1.I. VIEWPACK FOR 7-28-2020

**A New Garage at the Halliwell Residence**  
 2 Webster Road  
 Nantucket, Massachusetts

## Hill/Cabral Rooftop Solar Revisions

South Elevation  
SCALE: 1/4" = 1'-0"

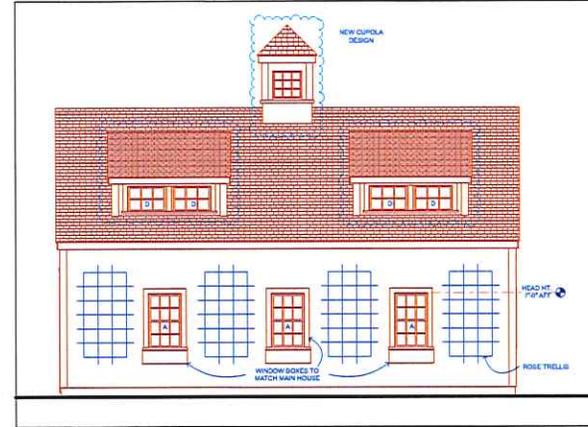
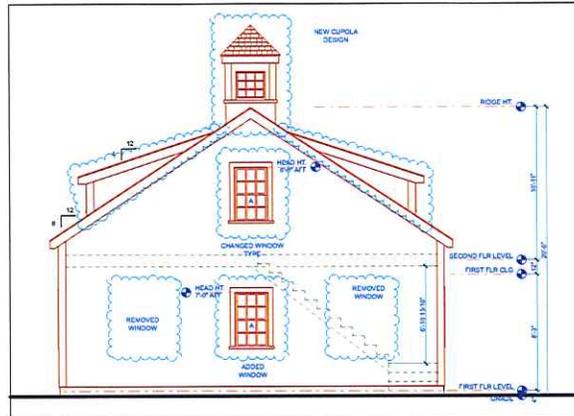
Historic Name: \_\_\_\_\_  
Original Date: \_\_\_\_\_  
Original Builder: \_\_\_\_\_  
Is there an HDC survey form for this building attached?  Yes  N/A  
**REVISIONS\*** (describe) 1. East Elevation window changes  
2. South Elevation Dormers & window changes  
3. West Elevation Deck & window change  
4. North Elevation Dormers & window changes  
\*Cloud on drawings and submit photographs of existing elevations.

Street View

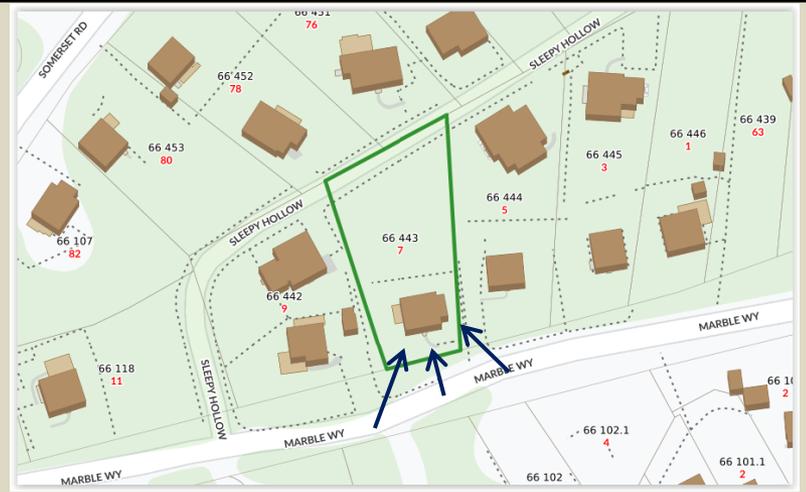
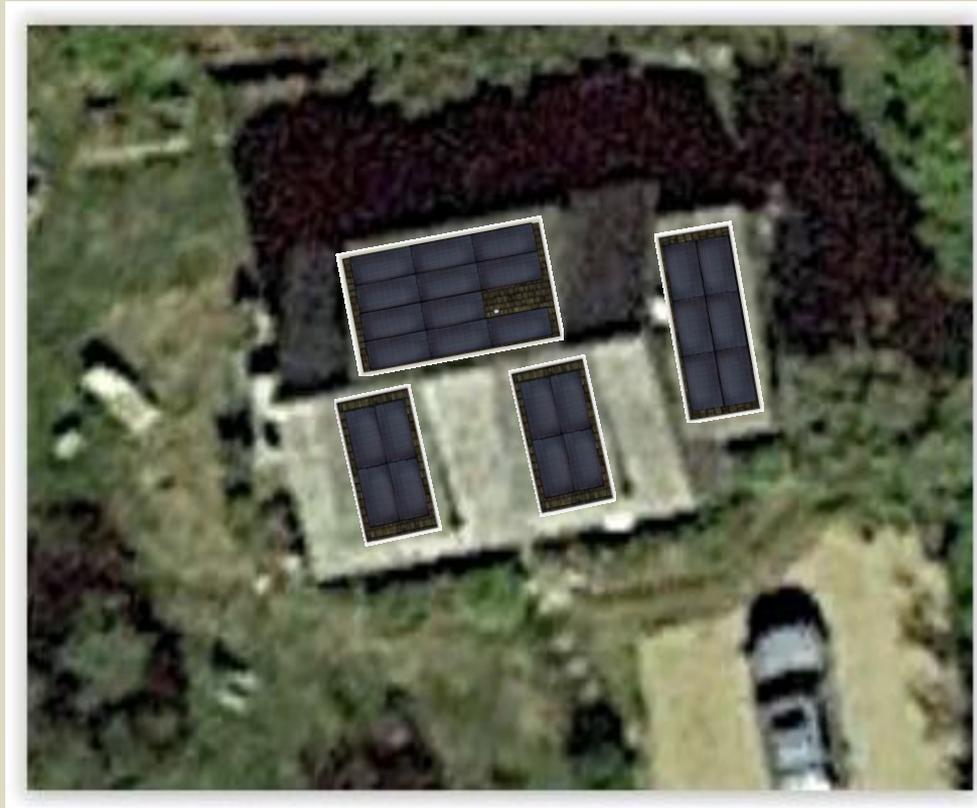
---- Commissioners indicated at last meeting that they were OK with panels on rear dormer and side shed dormer.

---- Commissioners indicated at last meeting that they would not approve panels on front of house due to visibility. We believe that solar panels on top of front dormers cannot be seen due to height of dormers and shallow pitch of dormers. **Because of this, we are requesting a view from road of front dormers.**

---- Original application had a solar panel at gable roof plane pitch, on either side of front dormers. **These two panels have been removed.**

Solar panels on rear dormer will not be visible from road.

Panels on right side shed roof and front dormers will have only thin edge visible

Solar panels on rear dormer (not visible in this photo) will not be visible from road

Solar panels on front dormers not visible due to height of dormers and shallow pitch of dormers

Solar panels on shed roof not visible

**29 BROAD STREET – JARED COFFIN HOUSE - RAILING CHANGE**

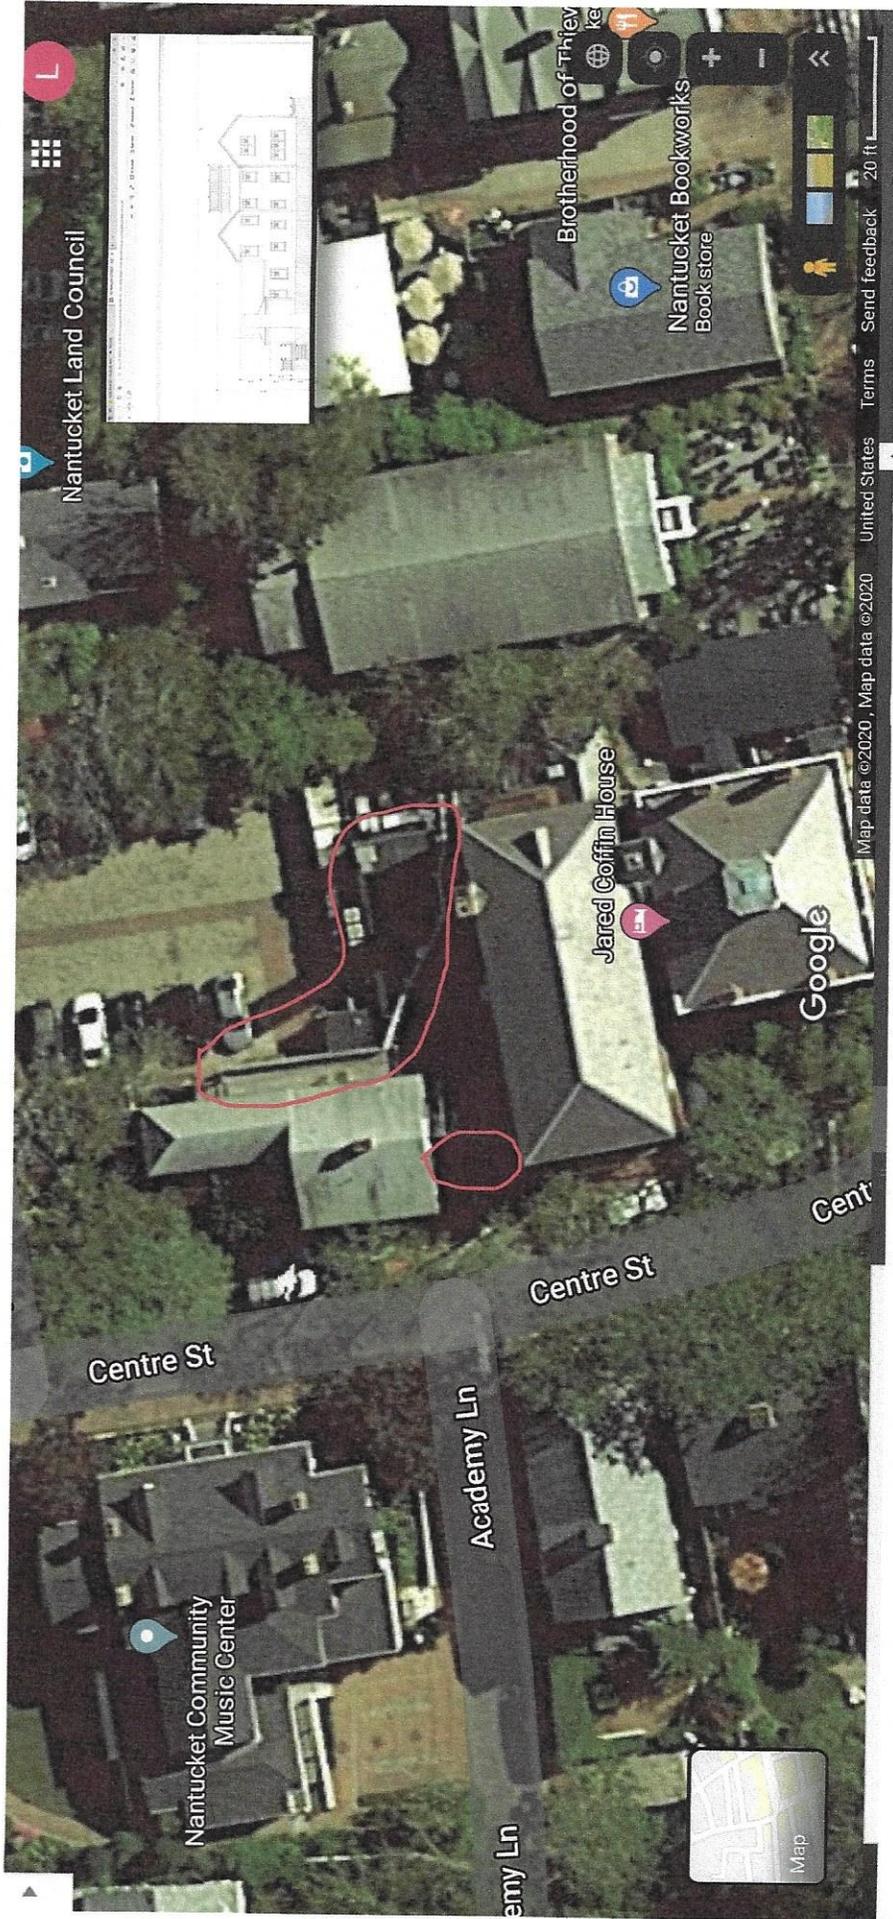
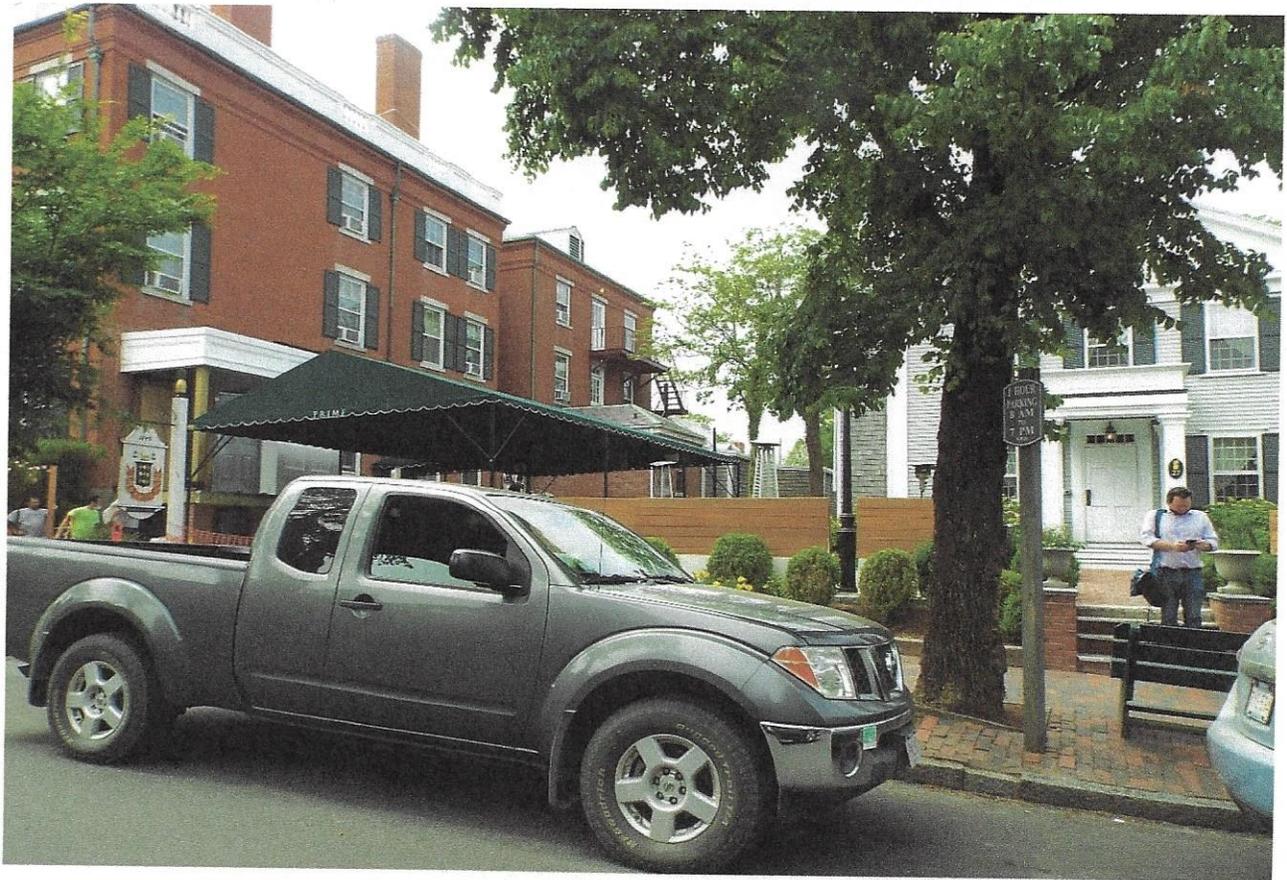
Historic Name: JARED COFFIN HOUSE REVISIONS: 1. East Elevation NORTH + SMALL SECTION ON WEST -  
 Original Date: 1845 (describe) 2. South Elevation ADD VINYL CLAD RAILING  
 Original Builder: 3. West Elevation SYSTEM IN PLACE OF ROTTEN  
 Is there an HDC survey form for this building attached?  Yes  N/A 4. North Elevation WOOD SYSTEM IN REAR UTILITY  
AREA OF JC HOUSE - SECOND FLOOR  
ONLY - + REPOSITION PART OF IT.  
 \*Cloud on drawings and submit photographs of existing elevations.

**JAMES-2 SACCACHA AVENUE (CISCO)  
 REV TO SHOWER AND RAILING TO CELLAR**

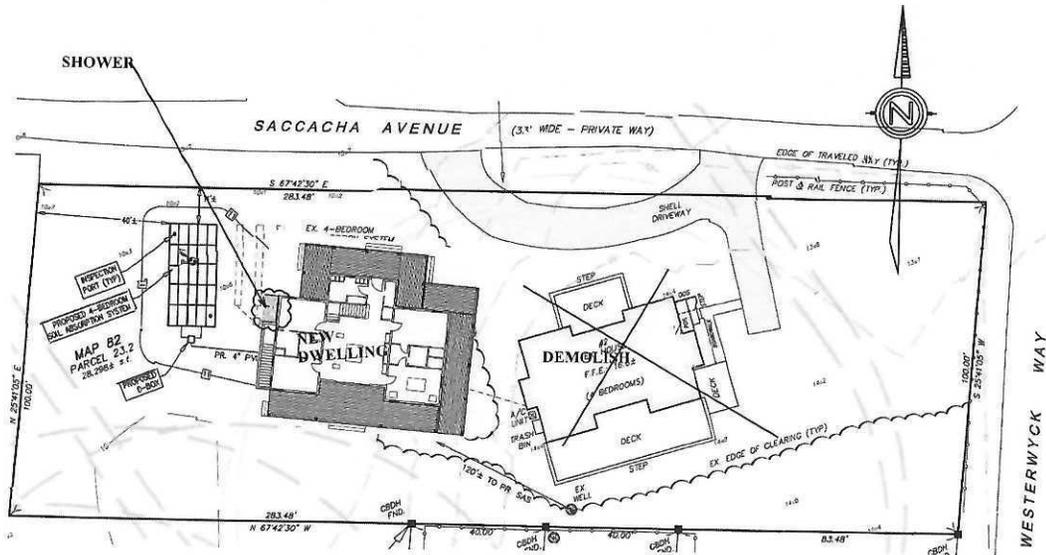
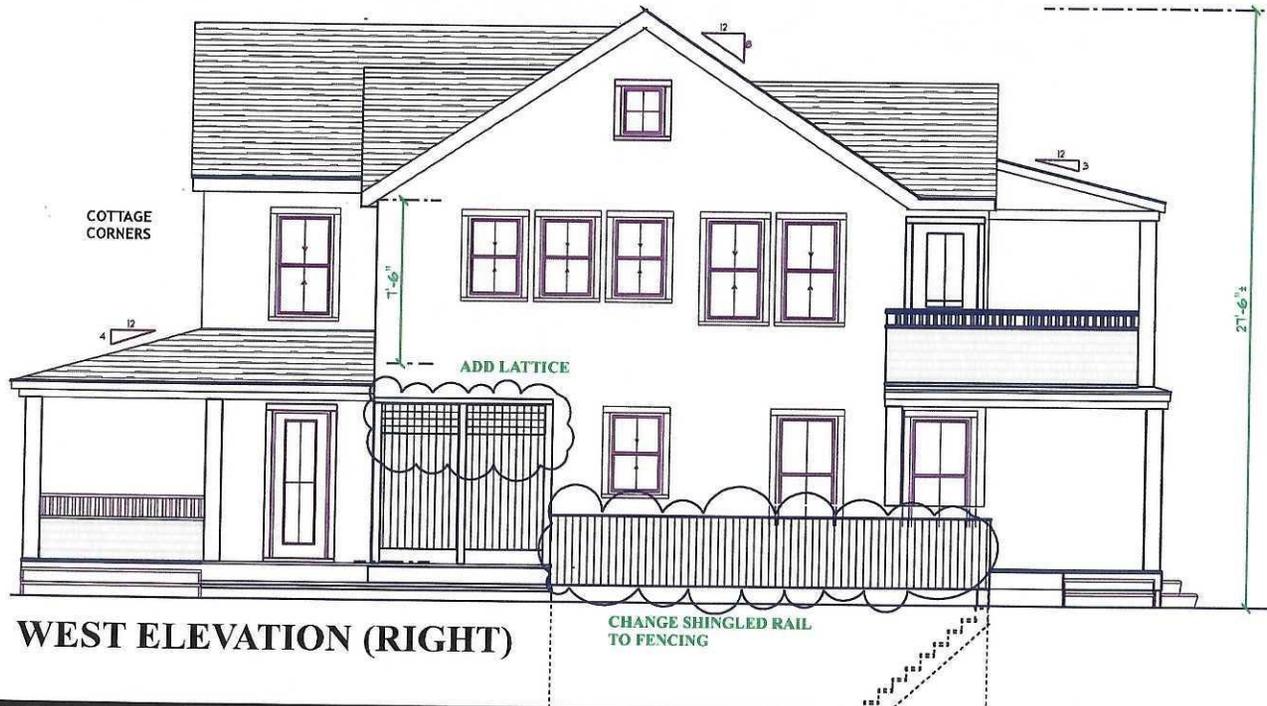
Historic Name: \_\_\_\_\_ REVISIONS\*: 1. East Elevation 1) ADD LITTLE SHOWER  
Original Date: \_\_\_\_\_ (describe) 2. South Elevation 2) changed railing to cellar change to fence  
Original Builder: \_\_\_\_\_ 3. West Elevation (NORTH) (WEST)  
Is there an HDC survey form for this building attached?  Yes  N/A 4. North Elevation

Exterior Shower and AC unit screening fence

Erisman Construction has used this type of outdoor structures on many properties in immediate area that they have worked on for years without issue by the HDC

More clear photos of the shower and fence show the existing in better light.

Because of the COVID mess, the posts were the only available size on ACK at the time. When it is all weathered in, it will look like the rest of the neighborhood and be typical of its area.
